<b>AMENDMENT OF SOLICITATION / MODIFICATION OF CONTRACT</b>			1. Contract Number	Page of Pages	
				1	69
2. Amendment/Modification Number  A0005	3. Effective Date  See Block 16	4. Requisition/Purchase Request No.	5. Solicitation Caption Systems Furniture, Casegoods and Related Products and Services

14. Description of Amendment/Modification (Organized by UCF Section headings, including solicitation/contract subject matter where feasible.) This amendment is for the following changes to Systems Furniture, Casegoods and Related Products and Services, Solicitation No. DCPO-2009-B-0020 issued on June 5, 2009:

## RESPONSE TO PROSPECTIVE OFFEROR'S WRITTEN QUESTIONS

## Exhibit A - Waterfront Specifications and Pricing

**Item: A**

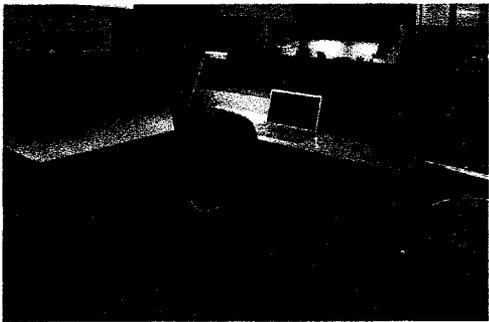
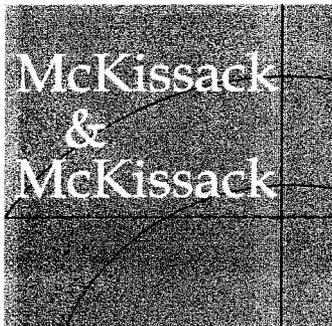
5. **Question:** On drawing 598 typicals A and AA both are listed as 3' x 4' while neither of them seems to be. Typical A including the wing panels measures closer to 4' x 4' and typical AA is closer to 4' x 6' but is listed in the specifications as 3' x 6'. Please clarify.

8. **Question:** Typical A – bid specifications state this is a 3' x 4' configuration, though the specs identify a 42" sectional panel. Please clarify if the panel should be 42" or 48" wide, or if the 42" is referring to the panel height + clearstory tile.

9. **Question:** Typical A, AA – drawing #SK-598 (page 78) states the typical should include the Pencil Drawer and Screen Arm, though the bid specifications state NOT to include any accessories in the price, but to include a BBF file. Which is correct? Drawing SK-598 or the bid specifications?

**Answer:** Typical A: 3'x4' station as described in the furniture specification.  
Typical AA: 3' x 6" station as described in the furniture specification.

**Answer:** 48"

**Answer:** Typical A to include all accessories except BBF Pedestal and Center Drawer. Typical AA to include all accessories except for Center Drawer. Listed below is the translation of "Accessories" as indicated in the specification submission:
